In the Matter of an application for Private Plan Change 84 (**PC84**) by **MANGAWHAI HILLS LIMITED** to rezone 218.3 ha of land between Tara Road, Cove Road, Moir Road and Old Waipu Road, Mangawhai from Rural Zone to the Mangawhai Hills Development Area.

Evidence of Peter Justin Kelly on behalf of Mangawhai Hills Limited

Transportation Engineering

Dated 13 May 2024

Figure 1: Roundabout Preliminary Concept Design

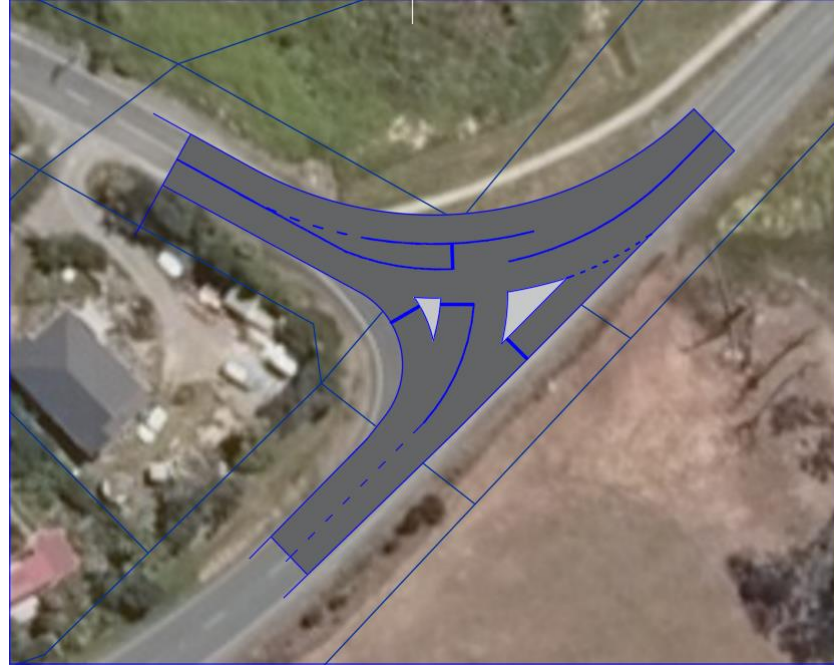
5. In Paragraph 3.8 of Mr. Arthanari's evidence, he expressed concerns with the intersection of Tara Road and Moir Street/Kaiwaka Mangawhai Road. I agree with Mr. Arthanari that current sightlines in this location are substandard and will require improvements to be made.
 - a. I note that from a vehicle queued on Tara Road, a Minimum Gap Sight Distance (MGSD) of 83 metres is required for vehicles to turn left or right. From my review of the boundaries and current road layout, approximately 90 metres of MGSD could be achieved through works within the road reserve. While this work may require some vegetation removal and retaining/regrading to occur within the road reserve, I do not consider it to be unachievable.
 - b. With respect to Safe Intersection Sight Distance (SISD), I consider there to be no issues with visibility to/from the north. To the south,

presently there is approximately 80 metres of visibility, which exceeds the minimum Stopping Sight Distance (SSD), based on an 85th percentile speed of 60 km/h, but is deficient when factoring in a downhill gradient of ~7.5% (requirement of 83 metres).

- c. From the removal and regrading of the berm, it is anticipated that sightlines could be increased to upwards of 100 metres. While this distance is deficient from the SISD requirements it would meet both the MGSD and SSD requirements. I also note that other measures could also be considered to lower the 85th percentile operating speeds to be closer to 50 km/h as opposed to 60 km/h. This would see the intersection having SISD values generally consistent with the Austroads standards when accounting for the downhill gradient and aspects of the Extended Design Domain criteria.

- d. I also explored very preliminarily the possibility of installing a roundabout at this intersection, as well as realigning the intersection to adjust the main flow direction between Moir Road and Tara Road, as opposed to Moir Road and Kaiwaka Mangawhai Road. I note that these are purely concept sketches and have not undergone any design reviews at this stage and are only provided for context in **Figure 1** and **Figure 2**.
